# North Dakota Department of Transportation

## ADDENDUM 1 – JOB 32

TO: All prospective bidders on project HRR-8-200(020)951, Job No. 32 scheduled for the April 10, 2015 bid opening.

Revised	3/31/15	STATE	PROJECT NO.	SECTION NO.	SHEET NO.
		ND	HRR-8-200(020)951	75	7

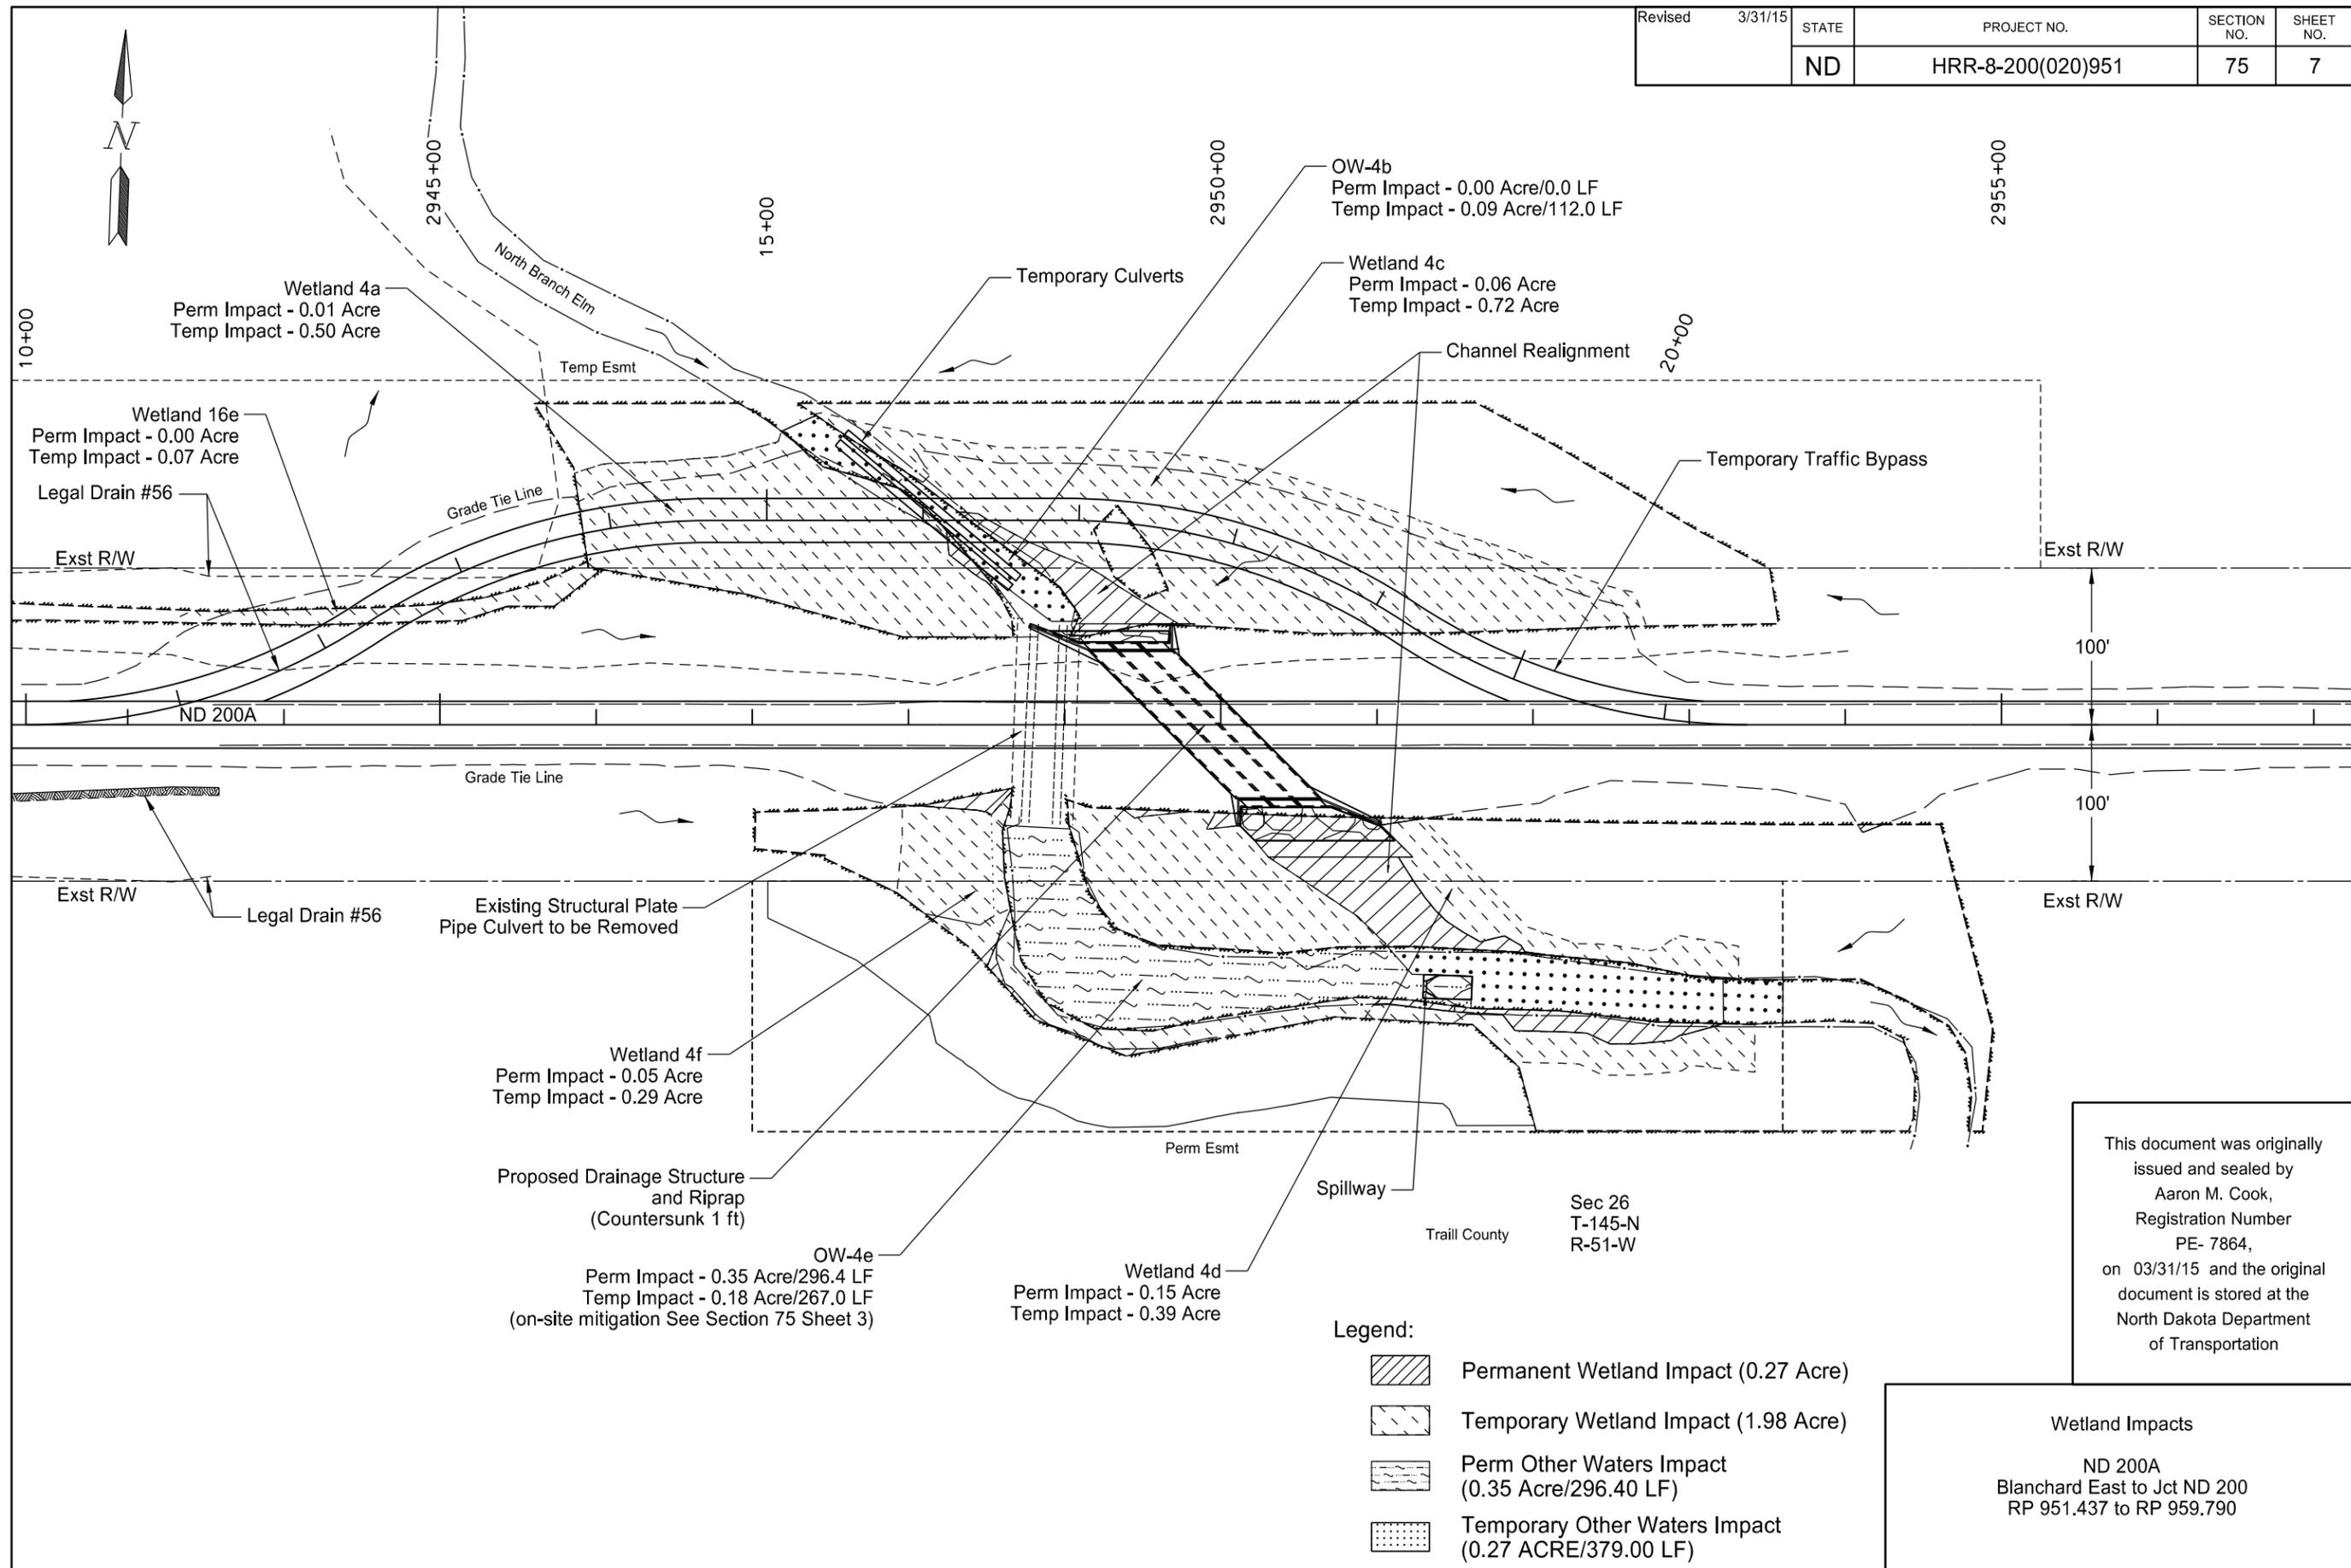
Revised ND 200A stationing to the correct station.

Revised	3/31/15	STATE	PROJECT NO.	SECTION NO.	SHEET NO.
		ND	HRR-8-200(020)951	75	13

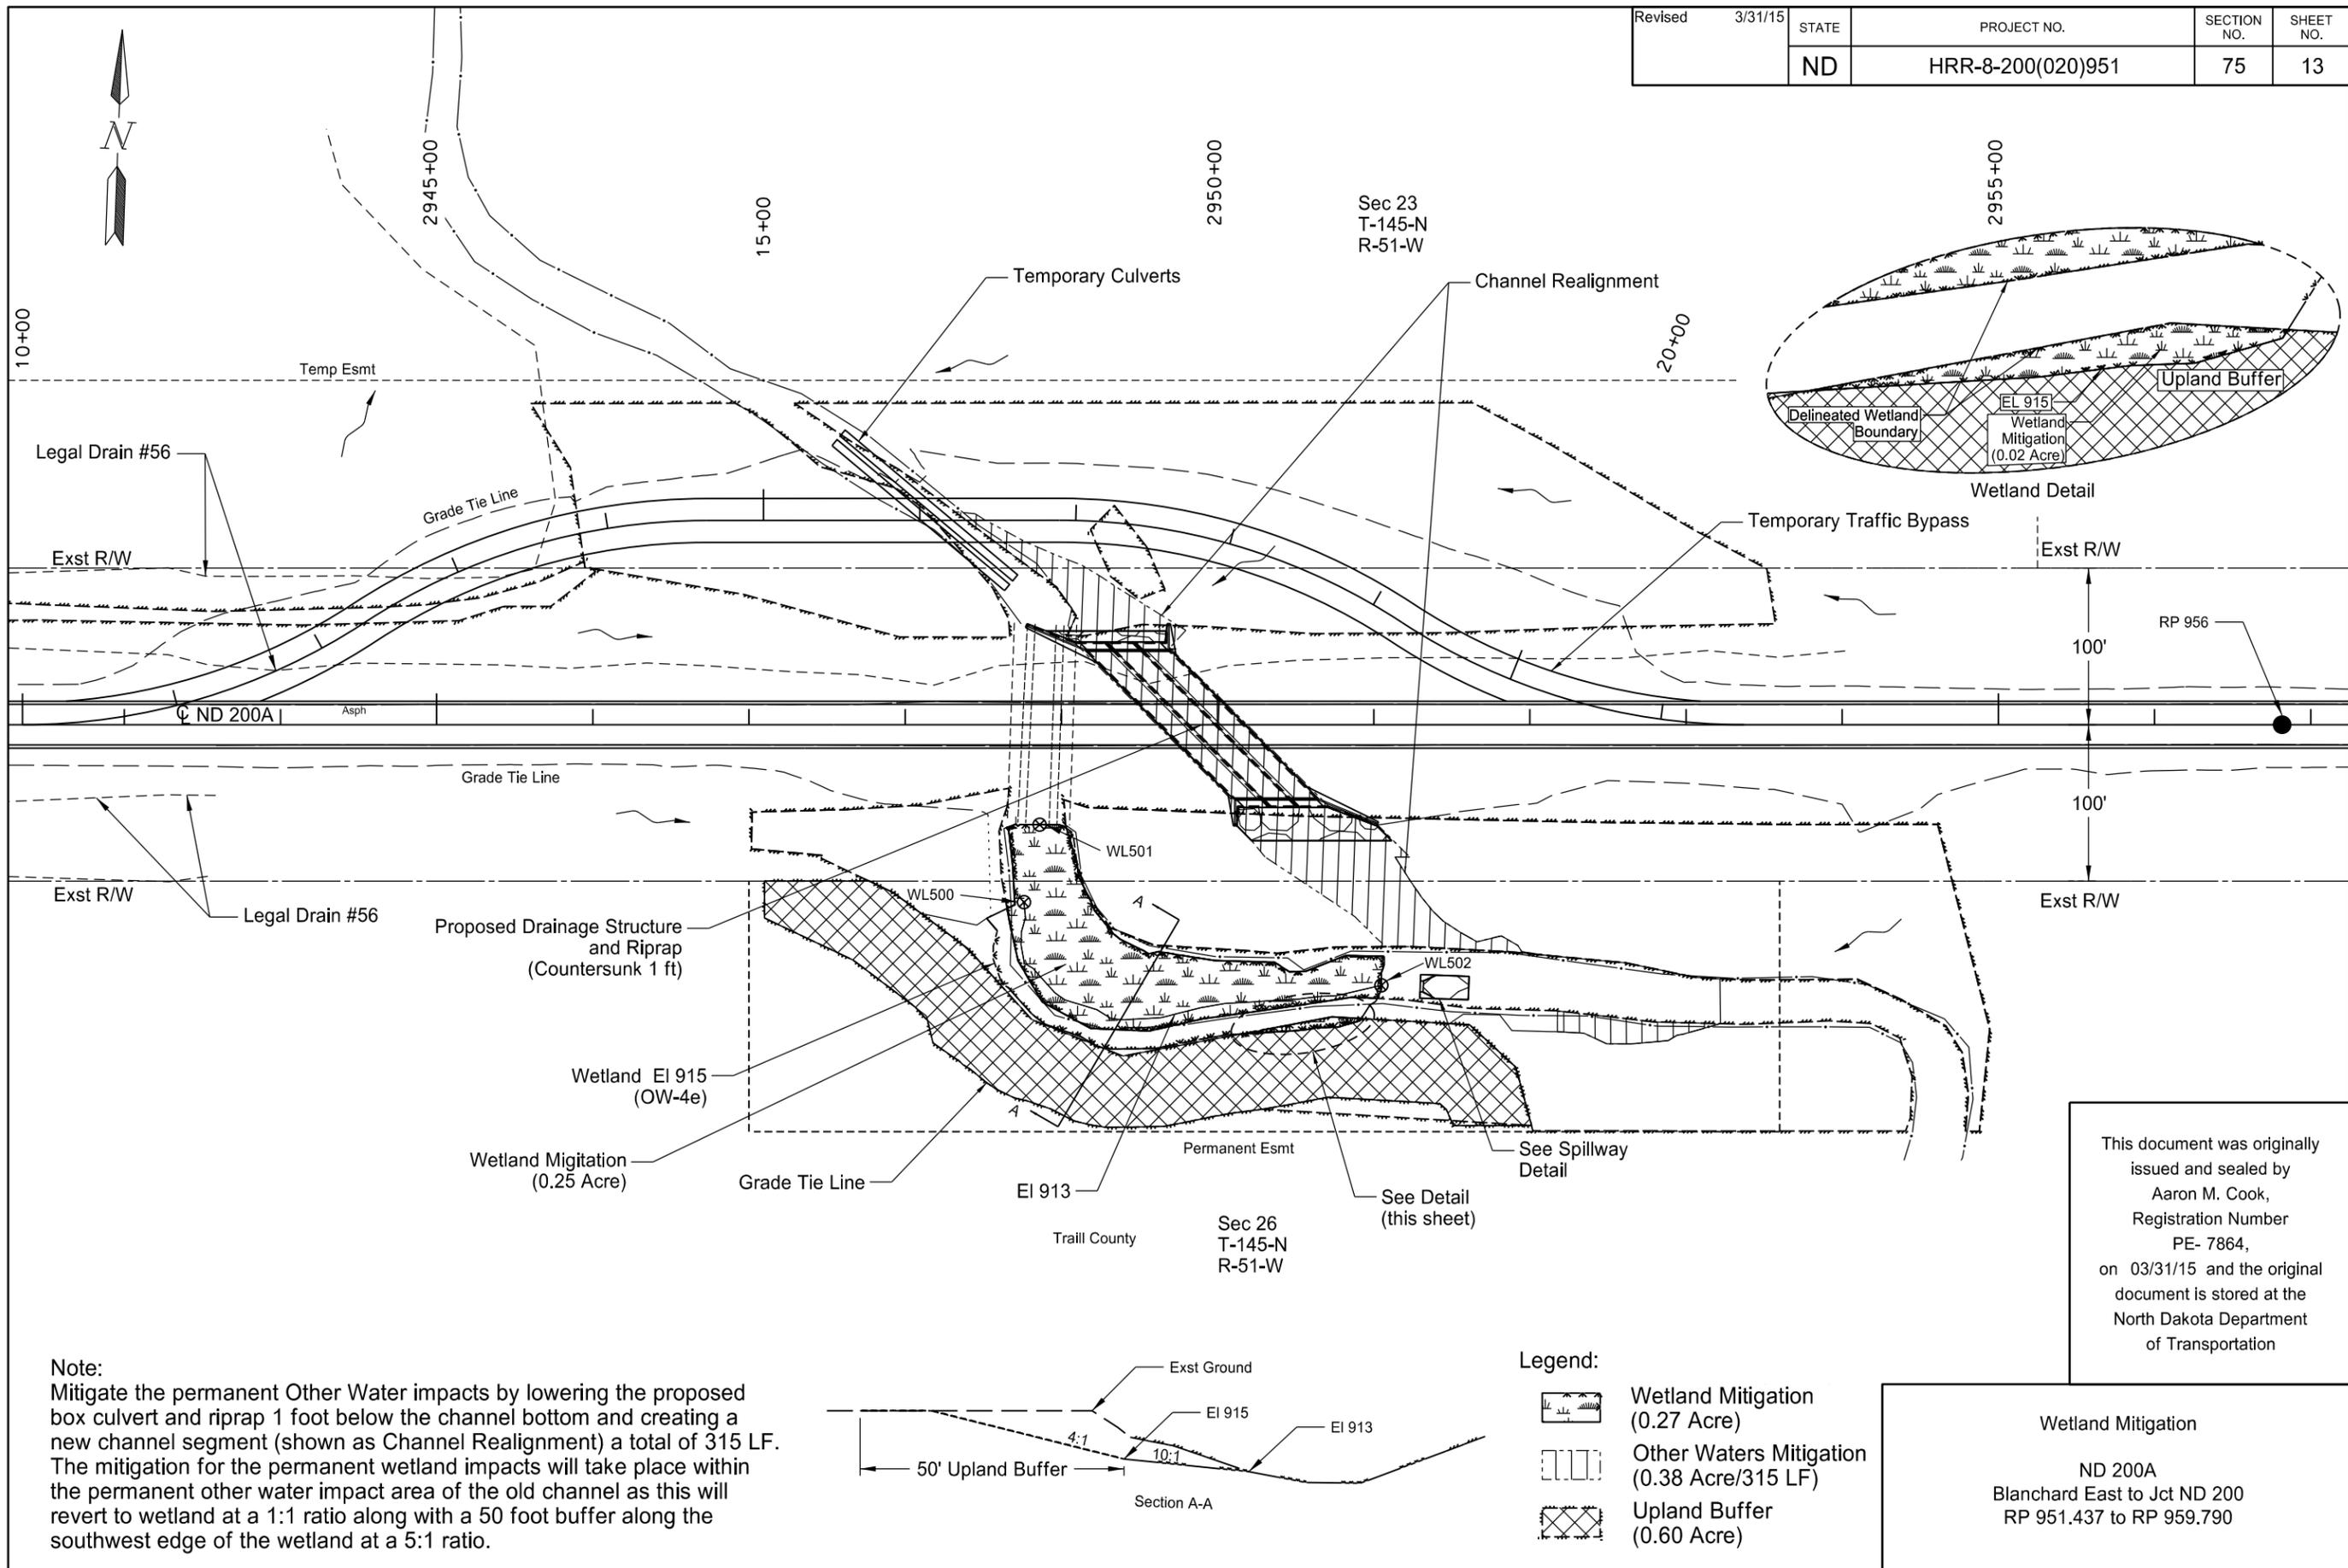
Revised ND 200A stationing to the correct station.
